Product Change Notification

Change Notification #:	111131 - 00
Change Title:	Intel Ethernet Server Adapters X520-DA2/SR1/SR2/LR1, EX520DA2G2P5/E10G42BTDA/E10G41BFSR/E10G41BFSRG1P5/E10G42BFSR/E10G42BFSRG1P5/E10G41BFLR (Spring Fountain DA2/SR1/SR2/LR1 OEM generic/Retail) PCN 111131-00 Label OUI block change
Date of Publication:	November 14, 2011

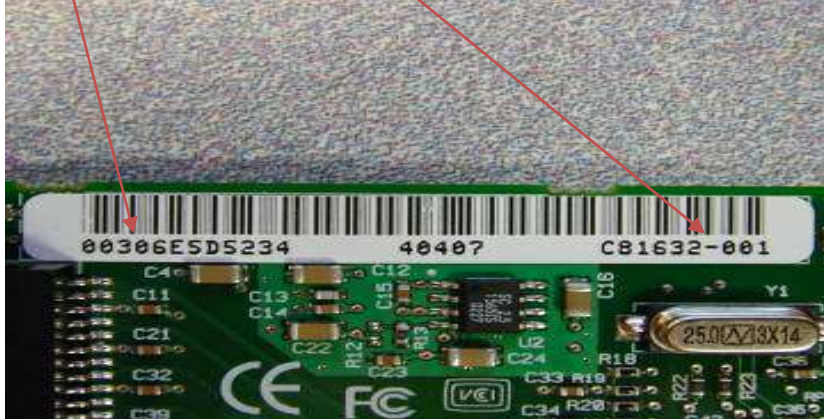
3n1 label change: The 3n1 label will change to reflect the new OUI Block number and PBA# dash roll (printed board assembly), as show in the picture below. The 3n1 label is placed on the Front side of the Printed Board. (picture example only)
